Change Order, Construction Manager as Adviser Edition

PROJECT: <i>(name and address)</i> Central Hardin High School Addn/Renov Cecilia, KY	CONTRACT INFORMATION: Contract For: BP 092-06 Gypsum Board Assemblies Date: July 14, 2021	CHANGE ORDER INFORMATION: Change Order Number: 105 Date: March 13, 2024
OWNER: <i>(name and address)</i> Hardin County Board of Education 65 W A Jenkins Road Elizabethtown, KY 42701	ARCHITECT: <i>(name and address)</i> JRA Architects 3225 Summit Square Place, Suite 200 Lexington, KY 40509	CONSTRUCTION MANAGER: <i>(name and address)</i> Alliance Corporation 116 E. College Street Glasgow, KY 42141
CONTRACTOR: <i>(name and address)</i> Bennett's Contracting, Inc. 109 Steve Drive Russell Springs, KY 42642

Cost associated with adding fire safety doors at gymnasium windows per COP 52R.

Proposal Request

PR 58
1

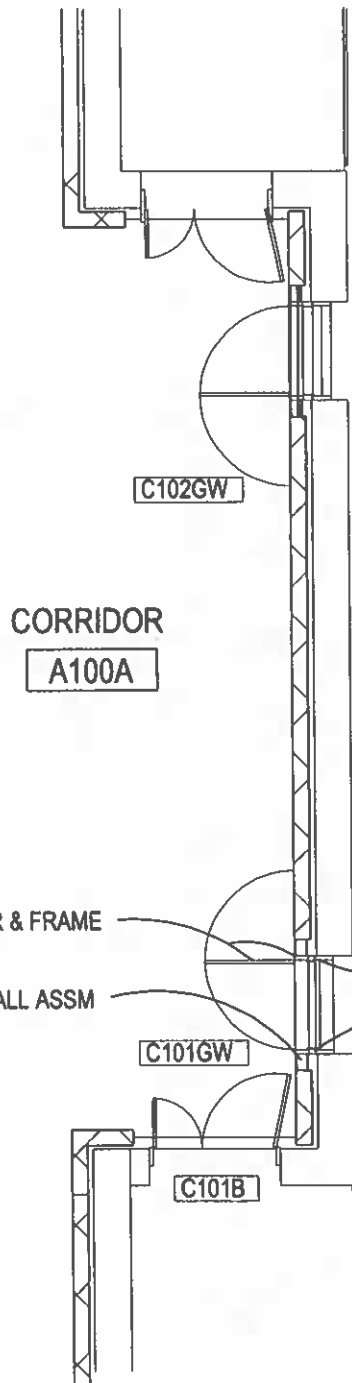
At the wall between the existing gym and the addition, provide a 3'-8" by 7'-0" HM door with 4-sided HM frame at each window location as well as new door hardware. Refer to attached drawing, PR 58-1, dated 1-15-24, and attached Hardware Set E06. Install frame in 2-hour fire rated shaftwall system using 4" studs. Install the fire rated joint system between the shaftwall and the CMU wall for the window.

Connect the magnetic hold open closers for both doors to the fire alarm system. Connect to the nearest available fire alarm circuit. Run the circuits above the lobby ceiling through the CMU wall, down the space between walls and into the head of the door frames to the closers. Install system smoke detectors located at bottom of the roof deck on the gym side of each of the 2 windows in the gym.

1. ALIGN DOOR FRAME WITH EXIST. WINDOW.
2. PROVIDE FLUSH, 3'-8" X 7'-0", 90 MIN. RATED HM DOORS.
3. PROVIDE 4 SIDED, 6-1/4" DEEP, HM FRAMES.
4. PROVIDE HARDWARE PER THE ATTACHED.
5. INSTALL FRAMES IN 2 HR RATED SHAFTWALL W/ 4" FRAMING. ALIGN FACE OF WALLBOARD W/ BACK OF RADI ON BULLNOSE BLOCK.
